**STAFF REPORT: SEPTEMBER 13, 2023 MEETING**

**APPLICATION NUMBER: 21-7584**

**ADDRESS: 1315 BROADWAY**

**SCOPE: REVISION TO PREVIOUSLY APPROVED DESIGN**

*Applicant drawing.*

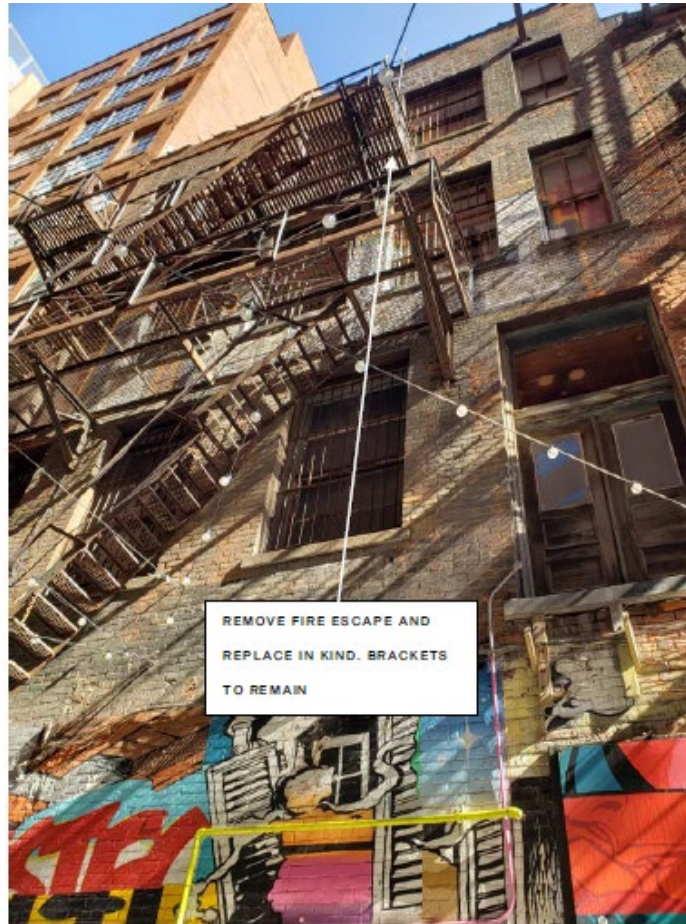
- As replacement window product information and sections of the existing and proposed units were submitted, staff conducted an analysis of the selected Quaker single-hung aluminum unit. *Please note: The condition and repairability of the existing windows remains in question. This window should only be considered once the Commission determines the existing windows are beyond repair.*

- TOP RAIL - The combined height of the top rail and trim of the new window is identical to the existing windows, and the profile for the new trim is very similar to the existing trim.

- MUNTIN BAR – Depth: The new muntin bars are about 1/2” shallower than the existing muntin bars (existing: 3/4” deep – new: 1/4” deep). Height: The new muntin bars are 1/4” shorter than the existing (existing: 2” high – new: 1-3/4” high).

- MEETING RAIL – The meeting rail height of the existing and proposed windows are similar with only 1/8” difference (existing: 1-7/8” high – new: 1-3/4” high).

- BOTTOM RAIL - The bottom rail of the new window is 1” taller than existing (existing: 4” high – new: 5” high), and the profile is drastically different.

- FEATURES THAT SHOULD BE MATCHED - An important consideration is the visibility of the windows to determine which components are most important to be matched. These windows are for a commercial building and will be installed in floors 2, 3 and 4; therefore, the top rails/trim and meeting rails will be fairly visible at the second floor, and less visible at floors 3 and 4. The muntin bars will be minimally visible at each floor and the bottom rails will not be visible at all.

- STAFF DETERMINATION – Based on the above analysis, it is staff’s opinion the proposed window is a close match to the existing windows.

*Applicant photos from 2021 application.*

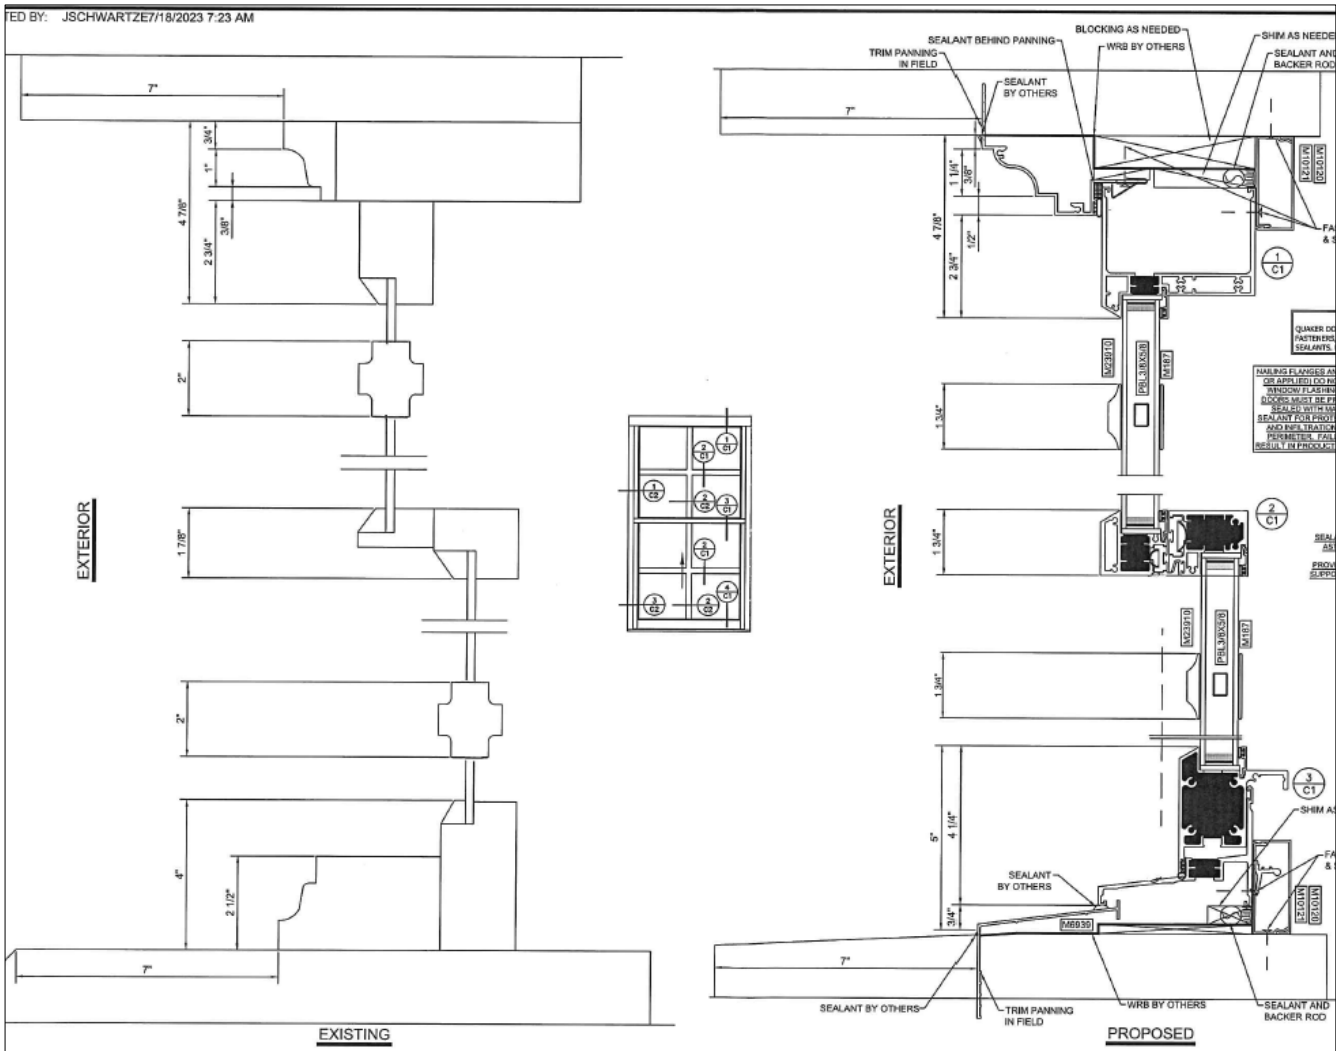
- It is staff's opinion the existing steel windows are character-defining features due to the operation, materiality, dimensionality, and pattern of window openings.

- In the 2021 application, Artisan Renovations concluded the steel frames and sash were in good condition and should be restored. In August 2023, Blackberry determined that the overall condition of the windows is poor. Only two exterior photos were submitted in Blackberry's report, so it is staff's opinion there is insufficient physical and visual documentation to substantiate the claim that the windows can't be adequately repaired.
